# Intel<sup>®</sup> Pentium<sup>®</sup> 4 Processor Specification Update

Release Date: November 2001

Order Number: 249199-015

The following figure will be added as Figure (new). THERMTRIP# Power Down Sequence

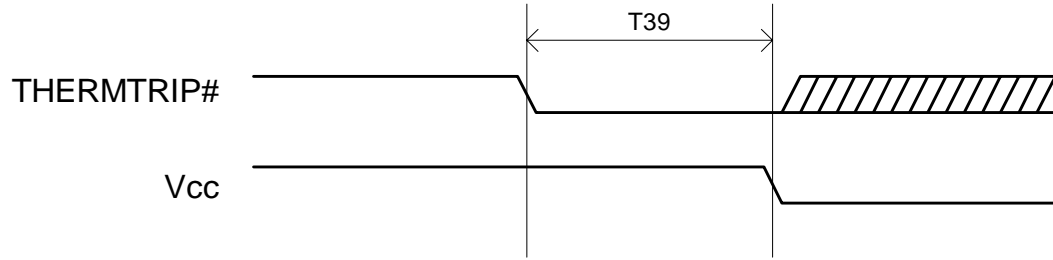
Several parts of the *Intel® Pentium® 4 Processor in the 423-pin Package* datasheet will be updated as follows to clarify the functionality of the Thermtrip# pin.

The description of THERMTRIP# in Table 32, page 69 will now state:

The following specification will be added to Table 13, page 24.

Assertion of THERMTRIP# (Thermal Trip) indicates the processor junction temperature has reached a level beyond which permanent silicon damage may occur. Measurement of the temperature is accomplished through an internal thermal sensor which is configured to trip at approximately 135°C. Upon assertion of THERMTRIP#, the processor will shut off its internal clocks (thus halting program execution) in an attempt to reduce the processor junction temperature. To protect the processor, its core voltage ( $V_{CC}$ ) must be removed following the assertion of THERMTRIP#. See Figure (new) and Table 13 for the appropriate power down sequence and timing requirements. Once activated, THERMTRIP# remains latched until RESET# is asserted. While the assertion of the RESET# signal will de-assert THERMTRIP# , if the processor's junction temperature remains at or above the trip level, THERMTRIP# will again be asserted after RESET# is de-asserted.

<u>T# Parameter</u>	<u>Min</u>	<u>Max</u>	<u>Unit</u>	<u>Figure</u>	<u>Notes</u>
T39: THERMTRIP# to removal of power	N/A	500	ms	(new)
